**SANDOVAL COUNTY
REGIONAL ANIMAL RESOURCE CENTER
VISTA SANDIA COURT
Bernalillo, New Mexico 87004**

**ADDENDUM NO. 01
FY26 - SCPW - 07**

November 17, 2025

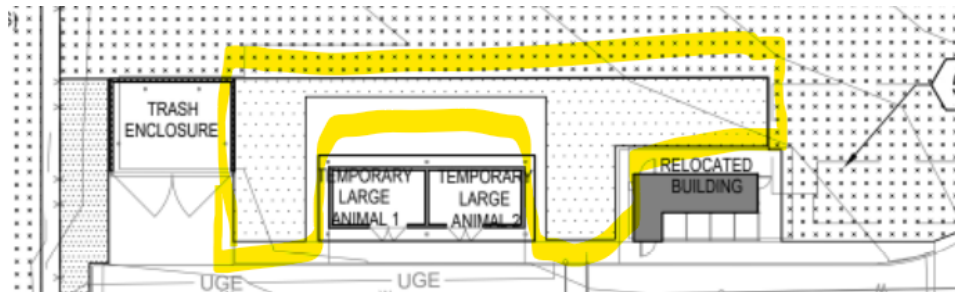
49. On Sheet LP101, there are two hatches that do not appear on the material schedule. Please clarify what materials are to be installed in these areas?

- a. This hatch has no call out and does not appear on the schedule.

- b. The area around the pond is called out as code 5, which matches a different material on the schedule. I am uncertain which is correct, the call out or the hatch. Since it is on the pond slope, I thought it may possibly be a different mix of material that was left off the material schedule.

Response: Refer to Item 6 in the REFERENCE NOTES SCHEDULE Sheet LP101.

Response: Yes, the pond slope was inadvertently left off the schedule and is code 7. The hatch and note are shown below.

FURNISH AND INSTALL "GSI REVEGETATION SEED MIX" PER D4/LP501 AND NMDOT SEEDING SPECIFICATIONS. AFTER SEED HAD BEEN BROADCAST, COVER WITH A ONE-ROCK DEPTH OF 2"-4" "COYOTE MIST" ANGULAR COBBLE AS AVAILABLE FROM JPR GRAVEL (505-503-7766). SMALL GAPS OF LESS THAN 1" BETWEEN COBBLES ARE PERMITTED. CONTRACTOR SHALL OMIT FILTER FABRIC AT DETENTION BASIN.

ALICE GATE DETAIL

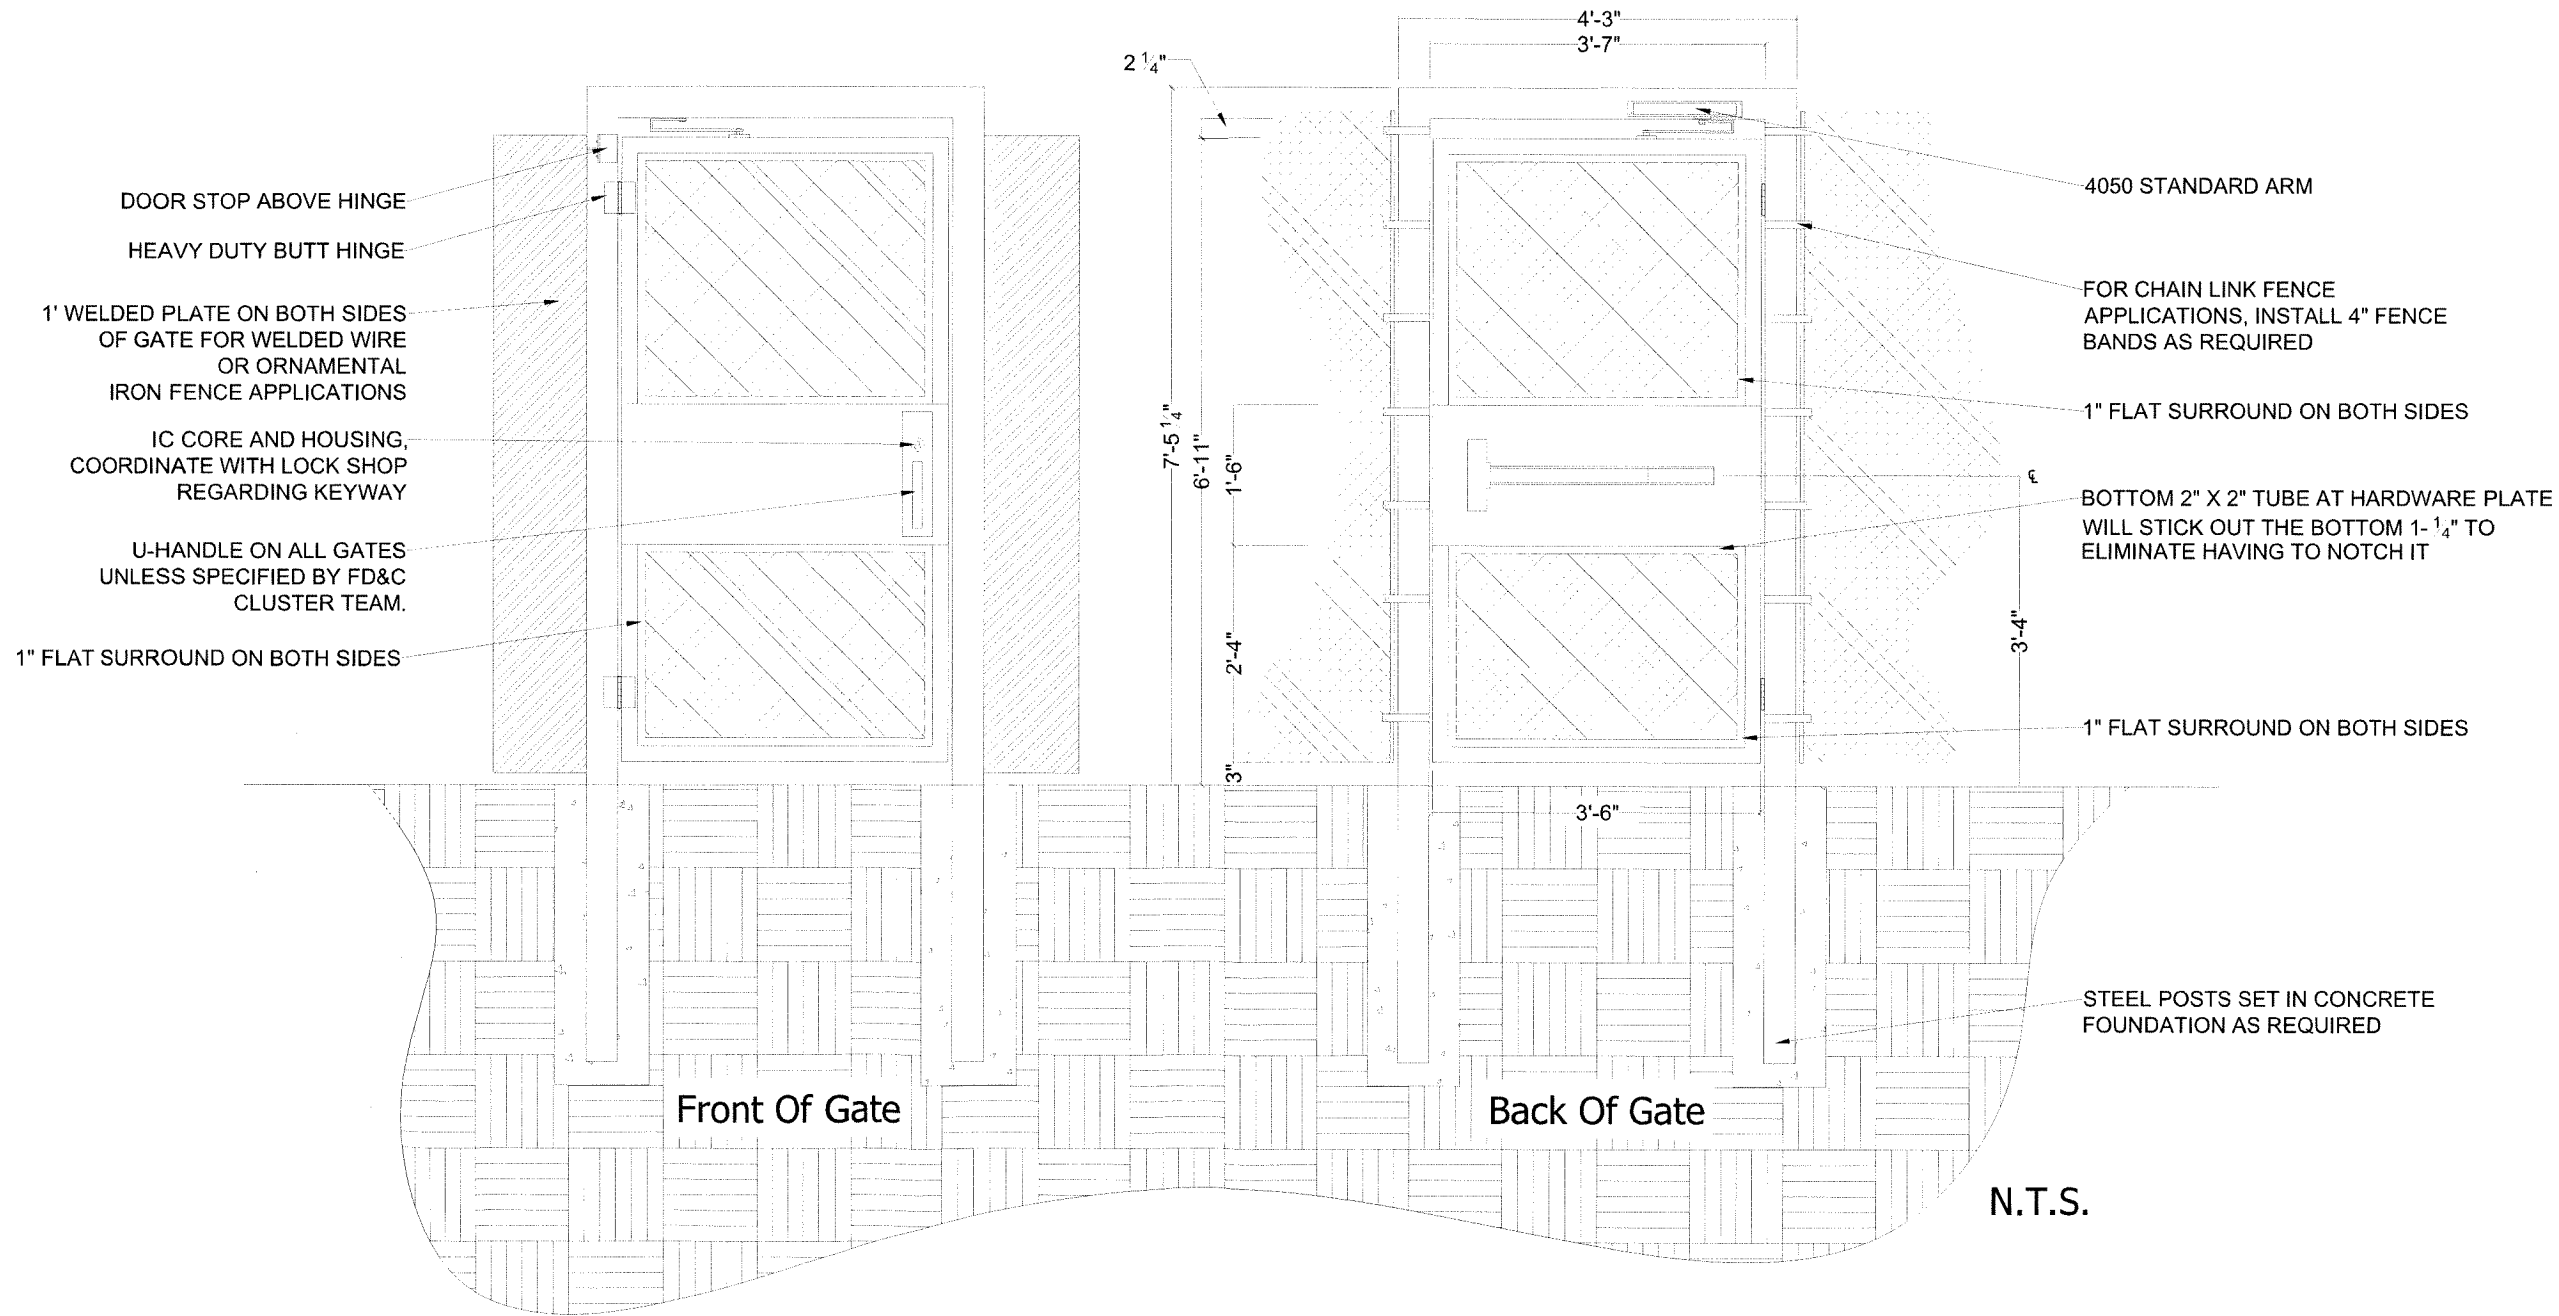
52. Sheet AS101- is mangate in security fence at SE corner of building an "Alice Gate" as shown at SW corner per keynote 576 / AS401? What is the height of the "Alice Gates"?

Response: 7'-5". Typical detail is attached.

C-101

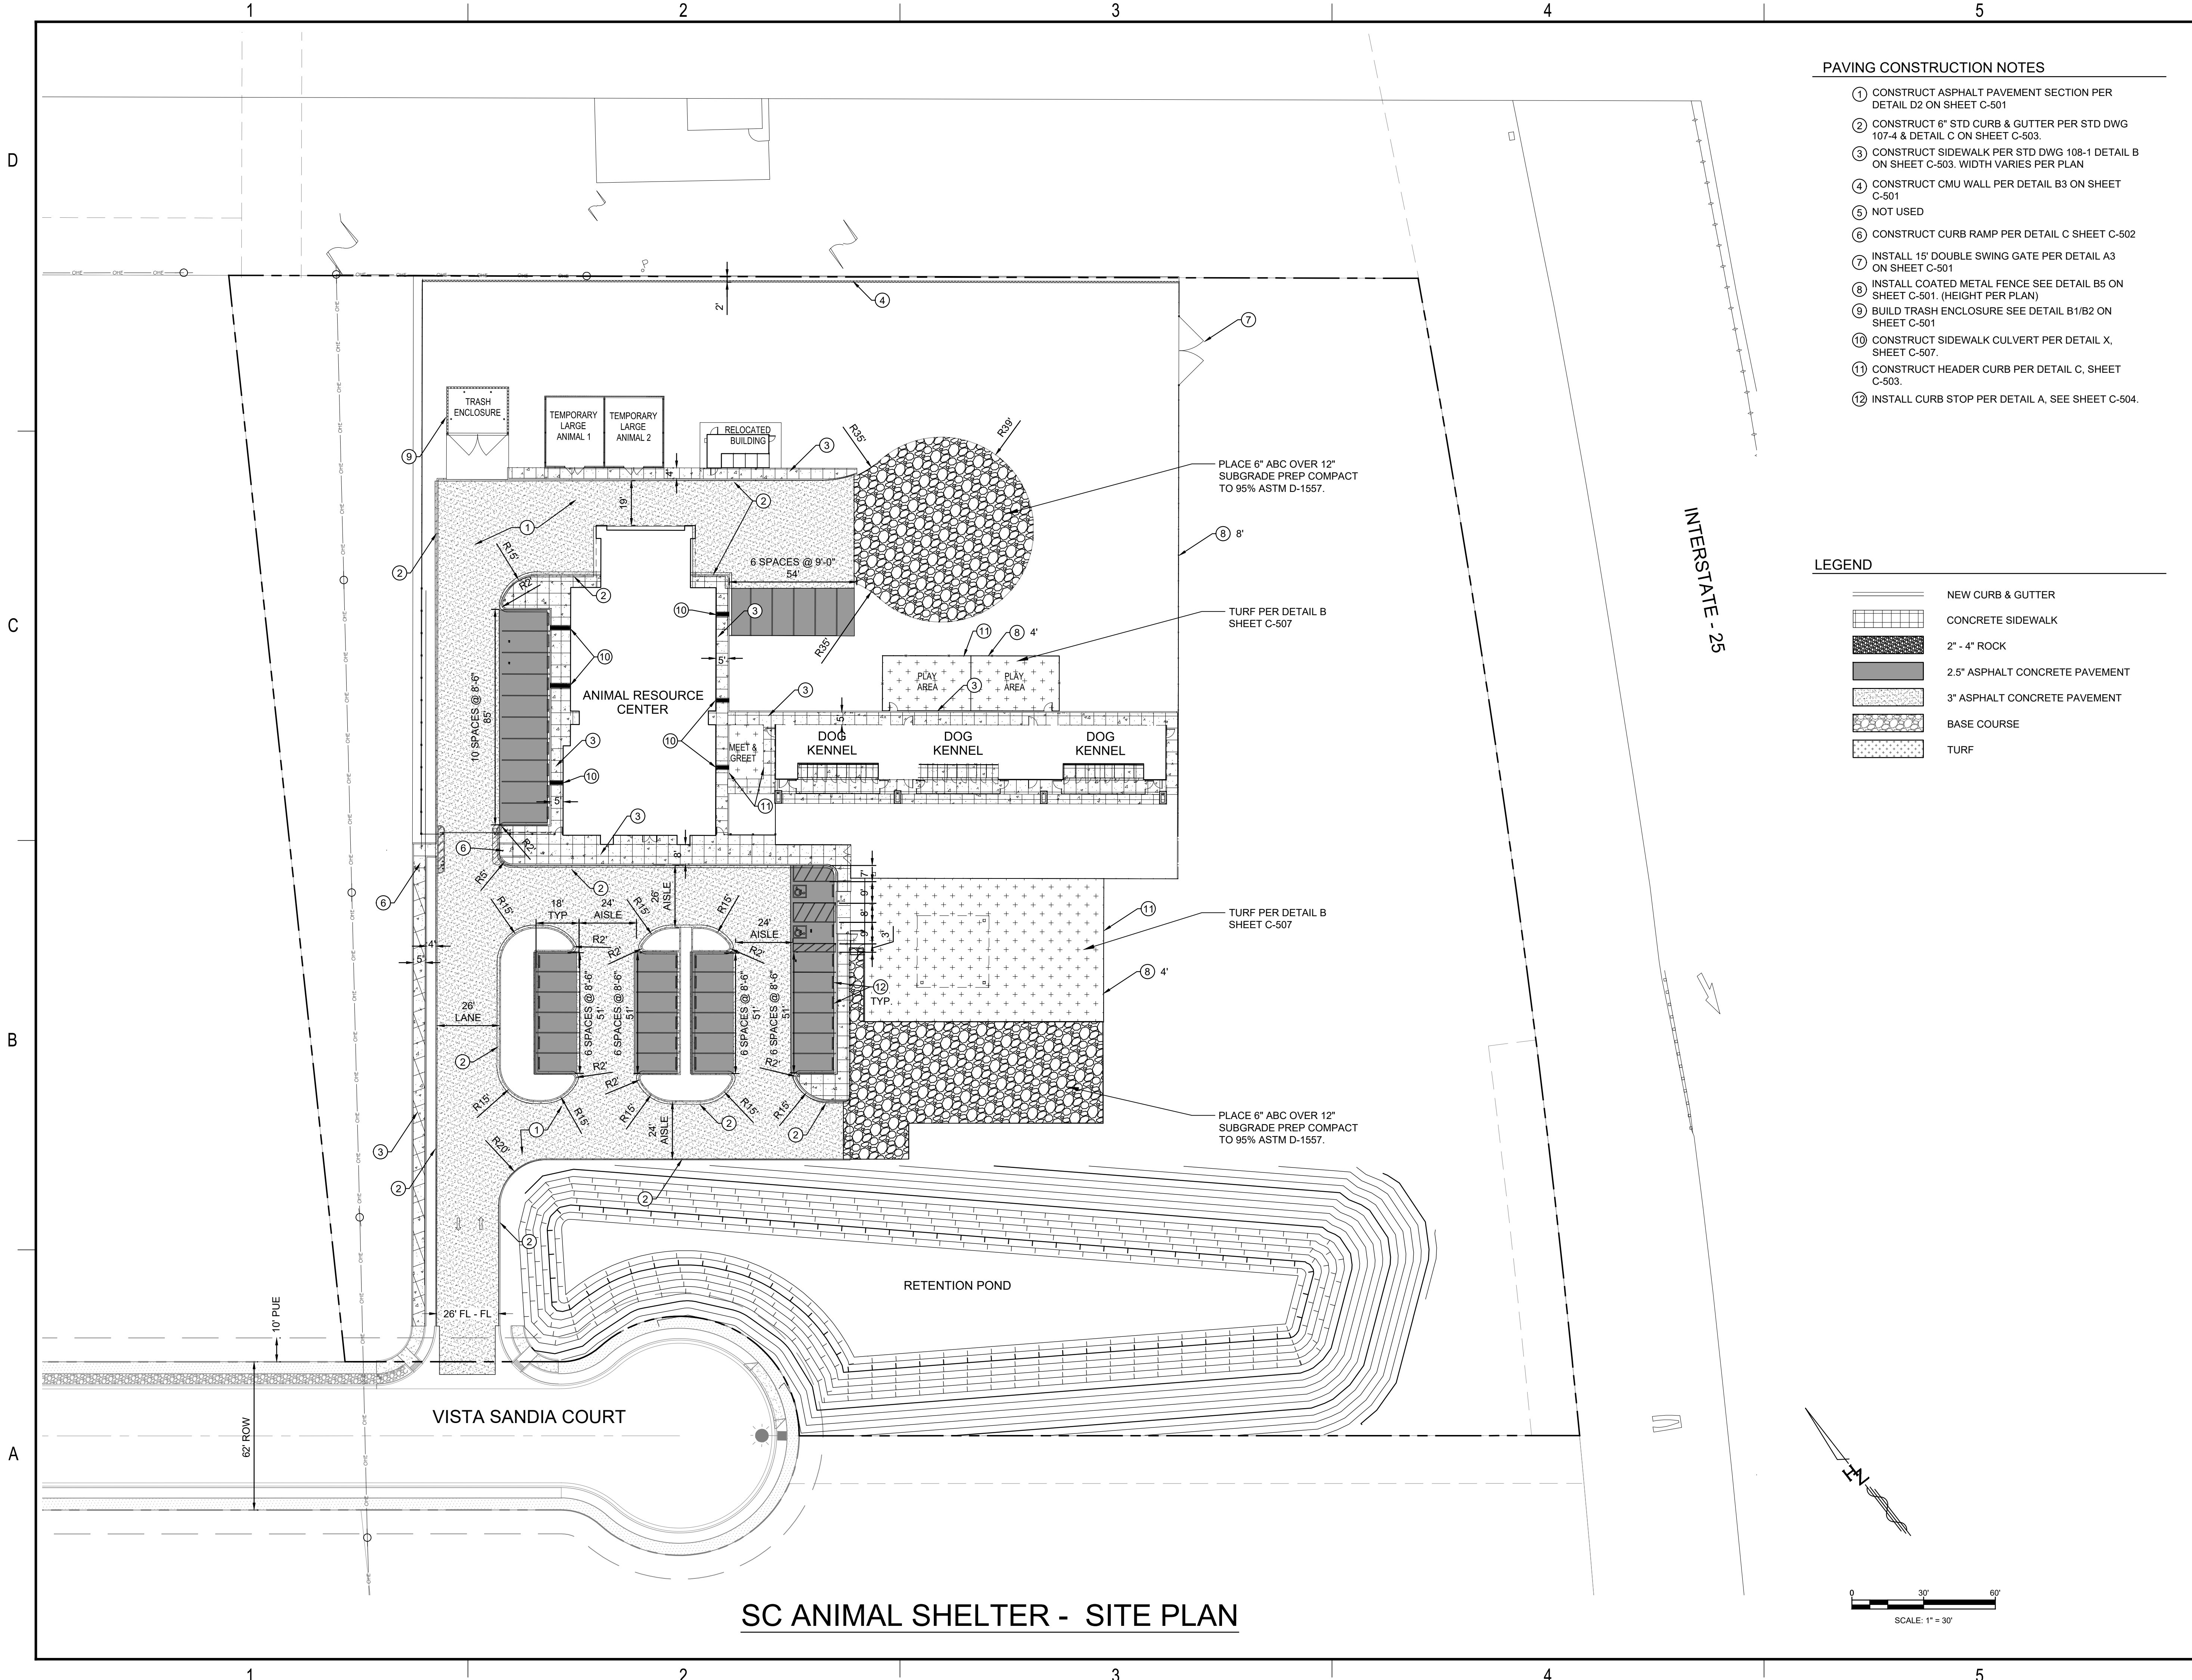
50. Sheet C101 keynote 10 refers to a detail that doesn't exhaust. Please provide detail.

51. Sheet AS101 and C101 – please clarify the size and type of double gate from sidewalk North of handicap parking spaces into landscaped area South of Kennel A?

56. Sheet AS101 and C101, please clarify which fencing is “mini-mesh”? Is all chain link fencing vinyl coated?
Response: Yes. Only fencing near public areas to the South, or around Play areas are required to be mini-mesh.
Fencing that ties to the Masonry wall on the north may be vinyl coated chainlink fencing per B5/C-501. Length is approx. 130’ from the masonry wall on the N property line to the south. On the west side the chainlink terminates at the security fencing. On the east side the chainlink changes to a mini-mesh fabric.

Response: Sidewalk culvert is shown on C1/AS401

Response: Provide 8' wide.
